WESTPORT PROJECT

DELTA HOLDINGS PTY LTD

Report and Recommendations
by the
Environmental Protection Authority

Environmental Protection Authority
Western Australia
Bulletin 281 May 1987

Figure 14 Plan of canals showing possible zones of erosion and accretion.

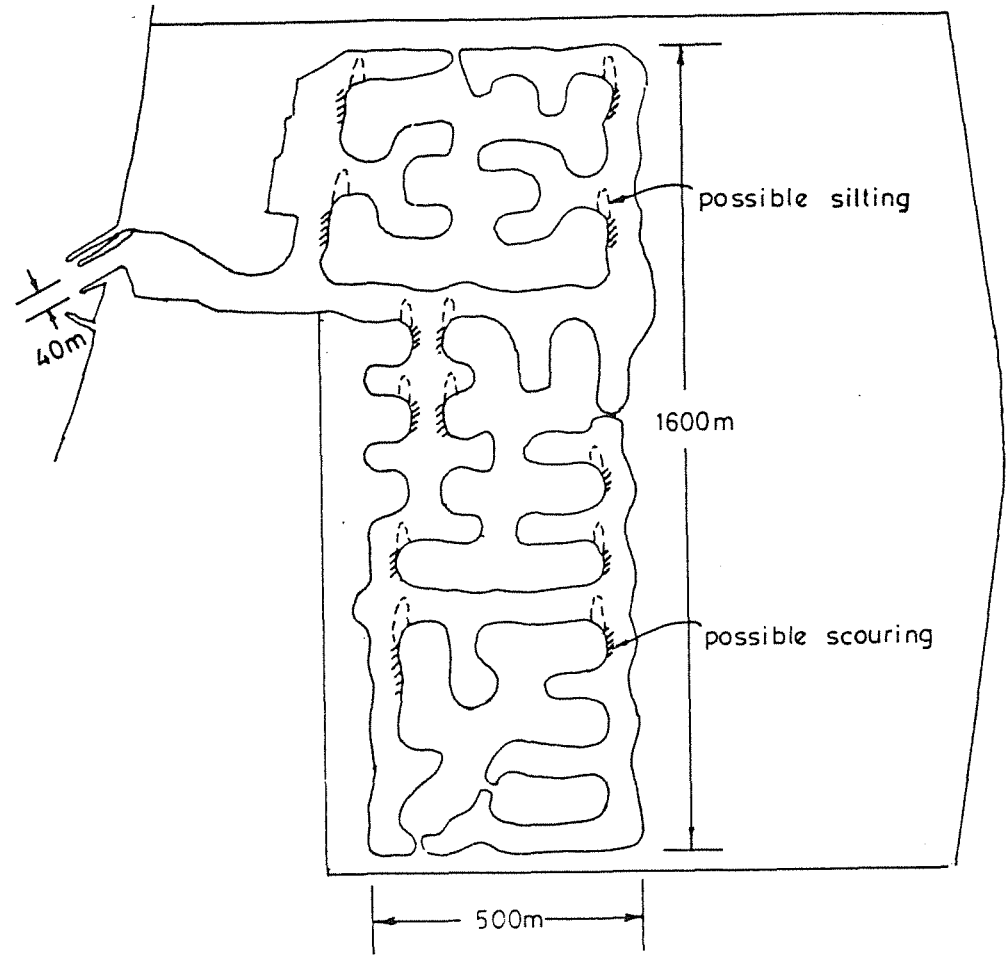
By taking this N-S length as 1600 m (see Figure 14) and the mean depth of water as 3.0 m and a wind speed of 10 m/sec the Reviewer's calculation (6) of set-up without waves is 2 cms which is unlikely to cause any significant exchange of water along the waterway. If a depth of 3.5 m is assumed this value decreases to 1.5 cms. An increase of wind speed to 15 knots increases the set-up for the smaller depth to about 5.0 cms, which is still extremely small.

Waves generated within the long N-S canals by southerly winds although small could be refracted towards walls supporting the allotments by the sloping bed adjacent to them. At these end allotments the waves will reflected obliquely and so cause scouring of bed with the small depths at the wall from zero to - 0.8 m (7). This material will be transported into the canals on the northern side and create shoaling as illustrated in Figure 14. This will create a navigation problem unless these land extremities have a bed protection preferably of a mattress type to withstand these short-crested waves. In the figure the zones most affected are designated. Where scouring occurs the supporting walls could collapse.
